Access Compliance Report

Public Rights-of-Way

Intersection ID: 2478	Main Street: WHISTLER'S_CHASE_DR	Cross Street: HIGHLAND_CREEK_PY	Location:	N
ADA ID: F8DE075A9AD0	Ramp Type: PerpDiag	Initial Pass/Fail: Pass	Overall Compliance: No	Severity Score: 0
Codes/Mitigation Info/Possible Solution		Field Measurements/Component Compliance

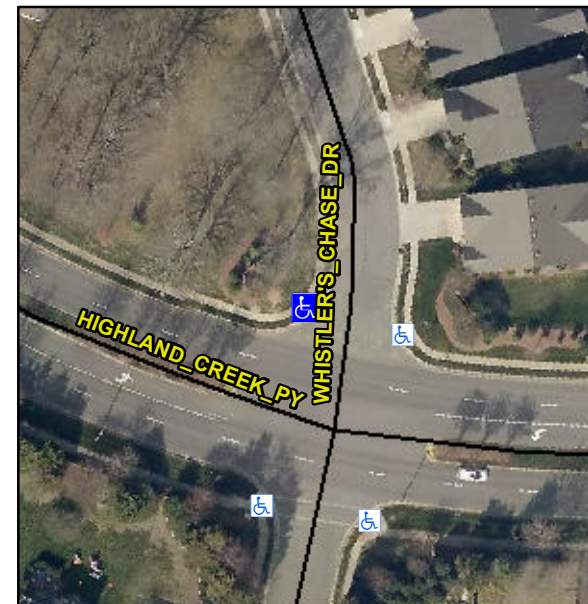
R304.2.2-Perp, R304.3.2-Para, R305.2

Remove & Replace Curb Ramp With Two New Directional Ramps or Equivalent.
